Enclosure 1

COLA will be revised as shown in this enclosure. These mark-ups are based on COLA Rev. 6 and replace those provided in RAI 03.07.01-29, Supplement 1 in their entirety.

3H.10 STP 3 & 4 Resolution of Issues with Subtraction Method of Analysis Identified by DNFSB

Figure 3H.6-212: Lateral Seismic Soil Pressure (psf) on RSW Piping Tunnel East Wall (Main Cross Section of RSW Piping Tunnel)

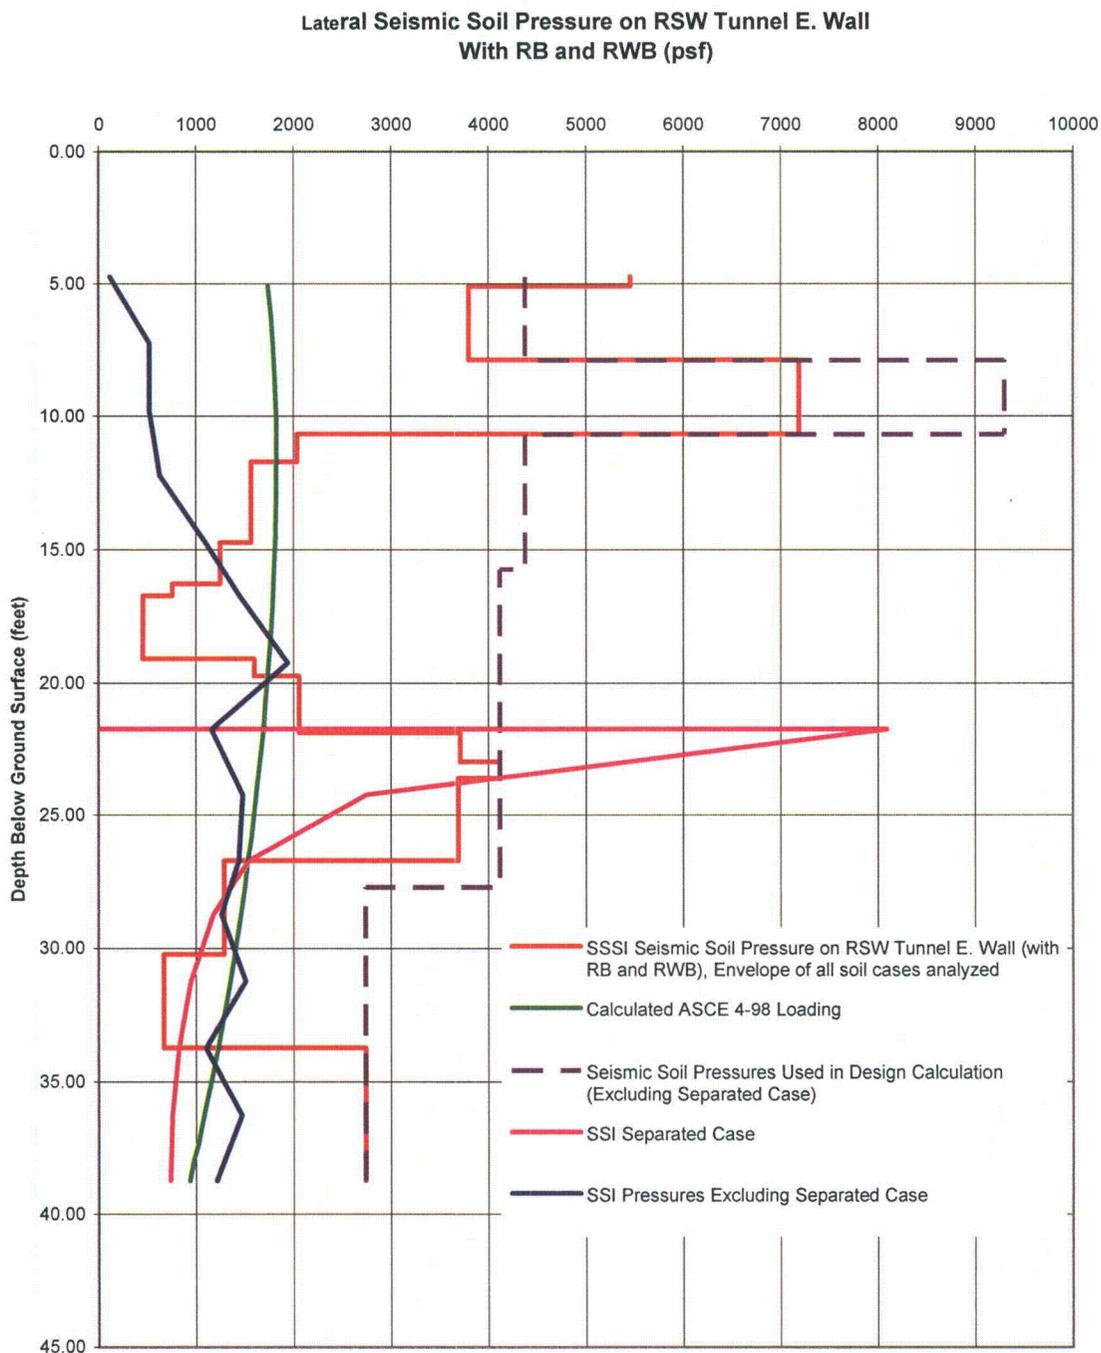
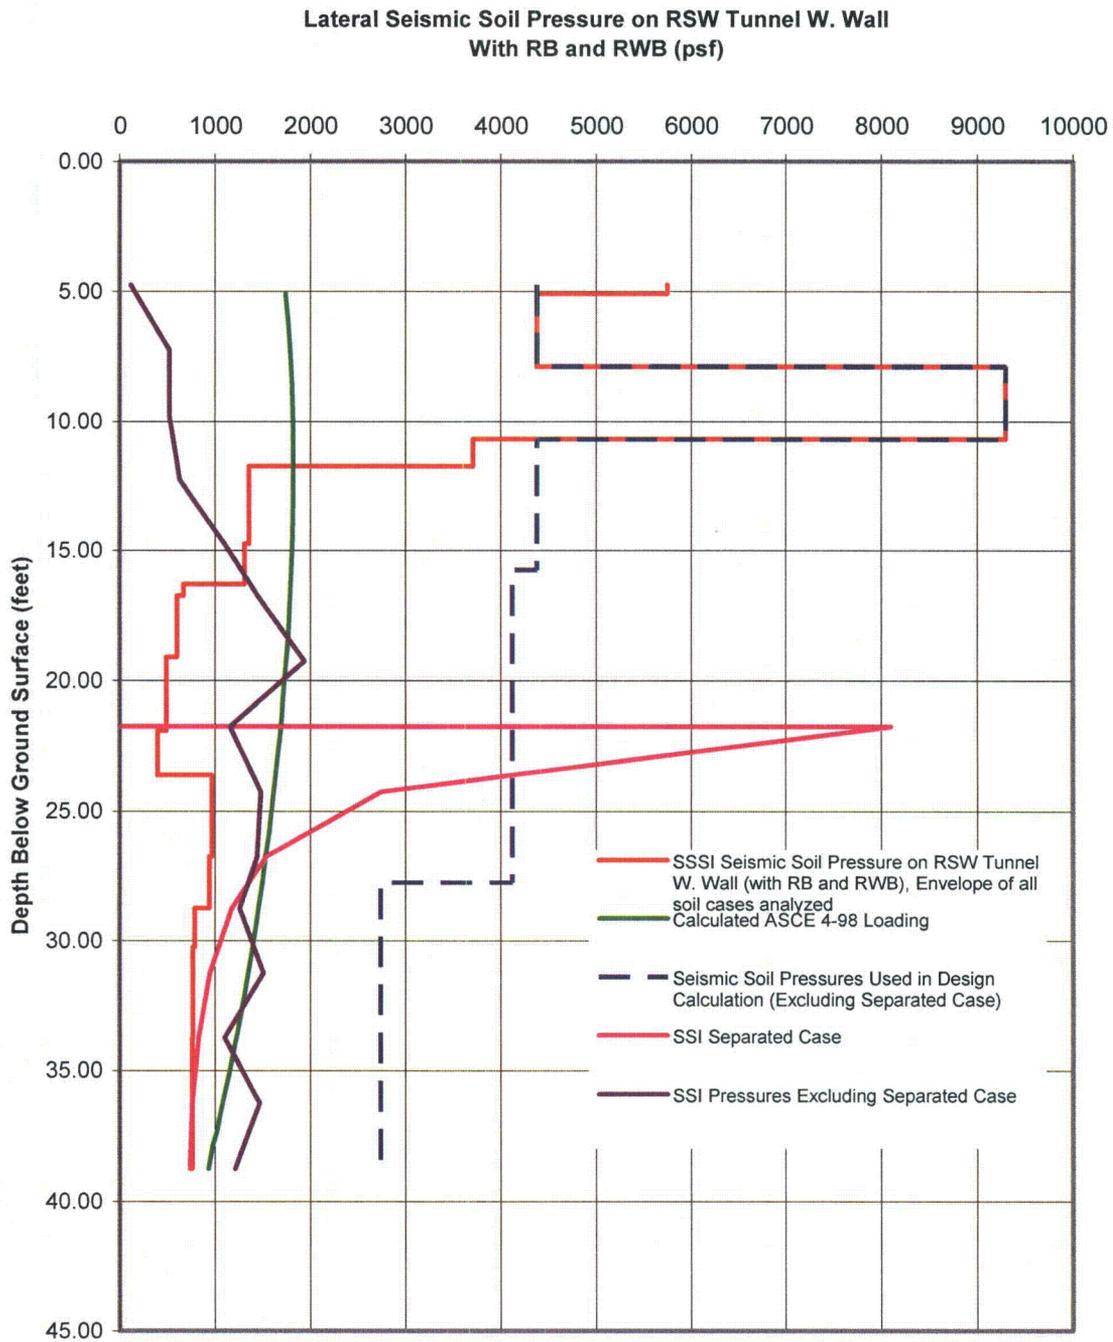
SSSI Analysis of the East-West 2D section of the RSW piping tunnel between the RWB and RB

Figure 3H.6-210 shows the structural part of the 2D plane-strain model of RB + RSW Piping Tunnel + RWB. Specifics of this SSSI analysis are as follows:

- Subtraction method of analysis is used. For resolution of issues with the subtraction method of analysis identified by the Defense Nuclear Facilities Safety Board (DNFSB) see Section 3H.10.

- The damping of structural part of the model is 4%.
- Groundwater was considered at 8 ft depth (26 feet MSL). Subsection 2.4S.12 and Table 2.0-2 now state the site groundwater elevation as 28 feet MSL. Therefore, a sensitivity analysis of this change in groundwater elevation was performed using the Diesel Generator Fuel Oil Storage Vault SSI model, which showed no significant effect on the analysis results. The ground water effect is included by using minimum P-wave velocity of 5000 ft/sec except for cases where use of this minimum P-wave velocity results in Poisson's ratio in excess of 0.495.

- Model is capable of passing frequencies of at least up to 35.9 Hz in the vertical direction and 61.6 Hz in the horizontal direction.
- Cut-off frequency for transfer function calculation is 33 Hz.

- Input motion is site specific SSE motion.
- The horizontal (E-W) input motion is applied at the grade elevation.
- Figures 3H.6-212 and 3H.6-213 show the resulting soil pressures.

Figure 3H.6-223: Enveloped Broadened Horizontal Direction Response Spectra for DGFOVS

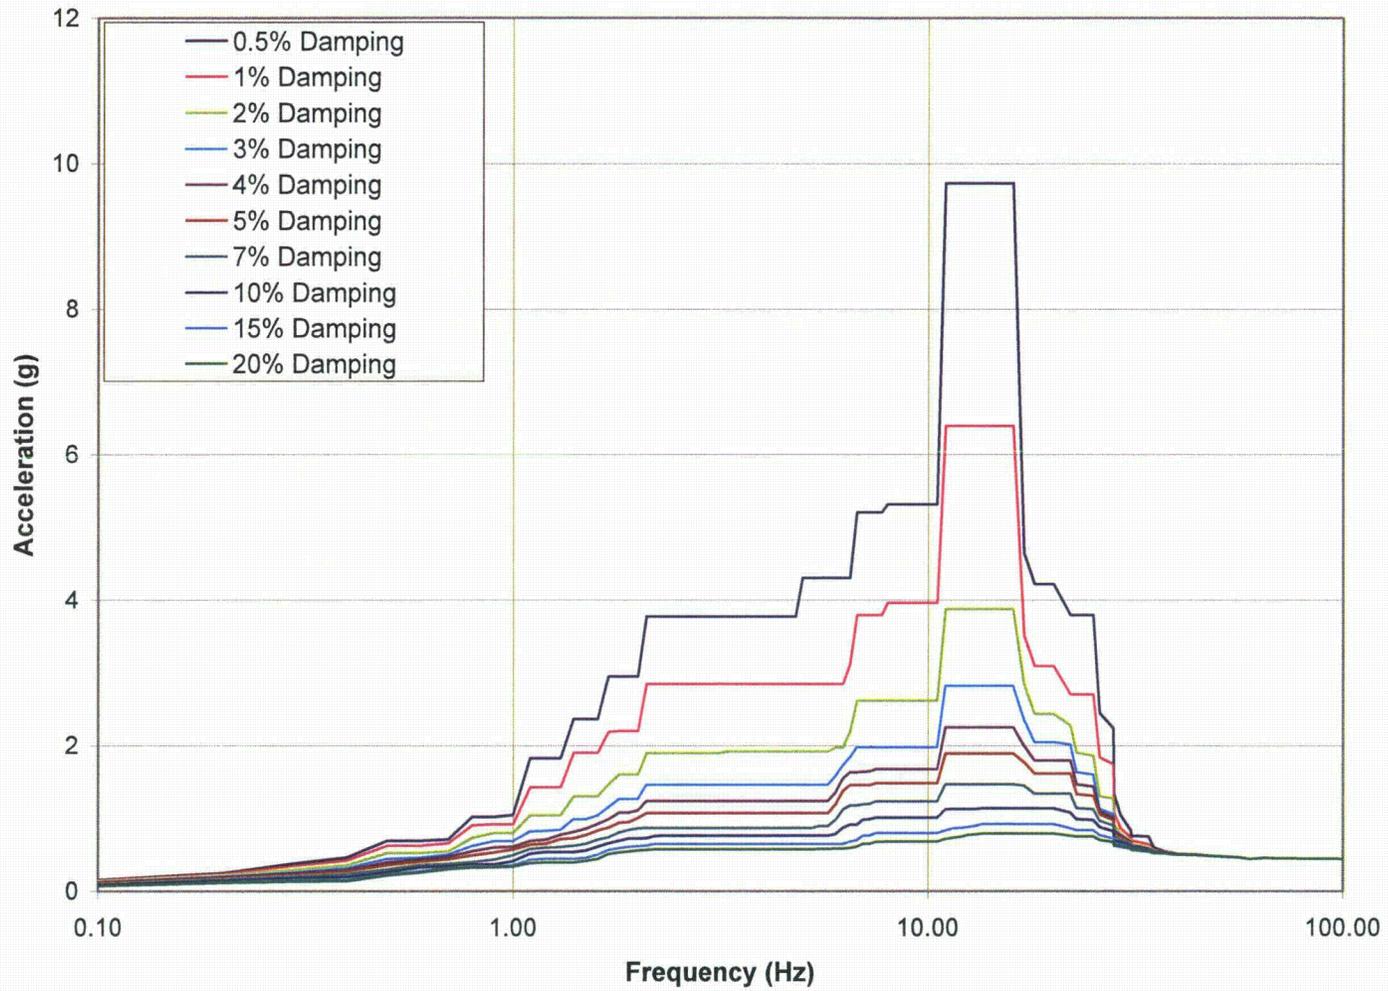
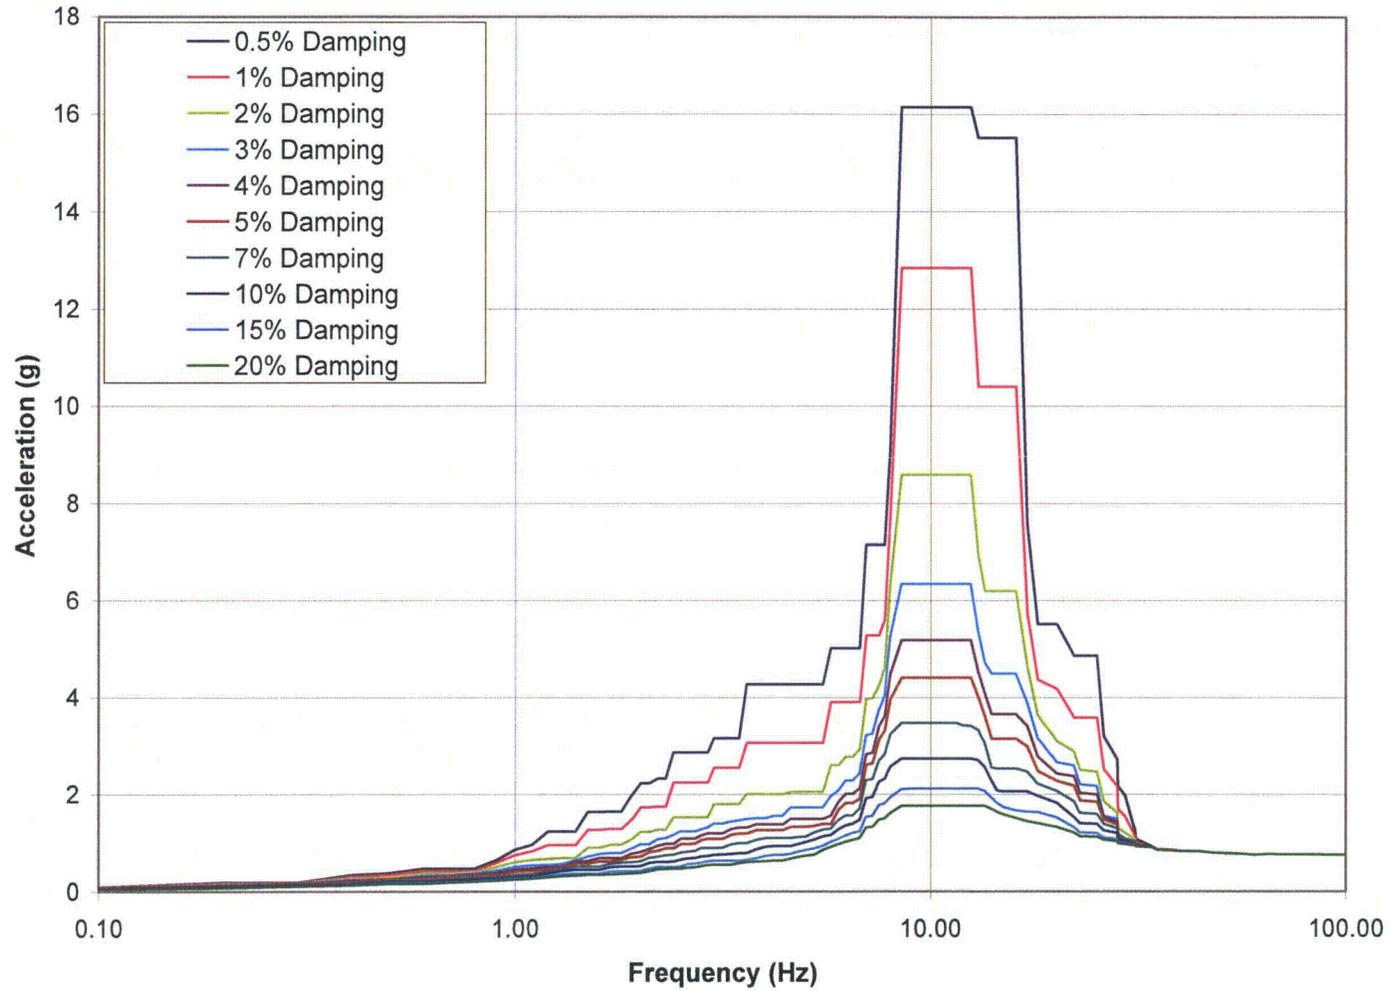
For all analysis cases, the responses due to two horizontal directions and vertical direction input motions are combined using square-root sum of squares (SRSS) method. Then, the responses from all analysis cases and all locations considered for spectra generation are enveloped to determine one set of un-widened horizontal and vertical response spectra. Finally, per Regulatory Guide 1.122, the enveloped un-widened response spectra are peak widened by plus-minus 15% on the frequency scale to obtain the final response spectra for DGFOVS. The resulting enveloping response spectra for DGFOVS are shown in Figures 3H.6-223 and 3H.6-224.
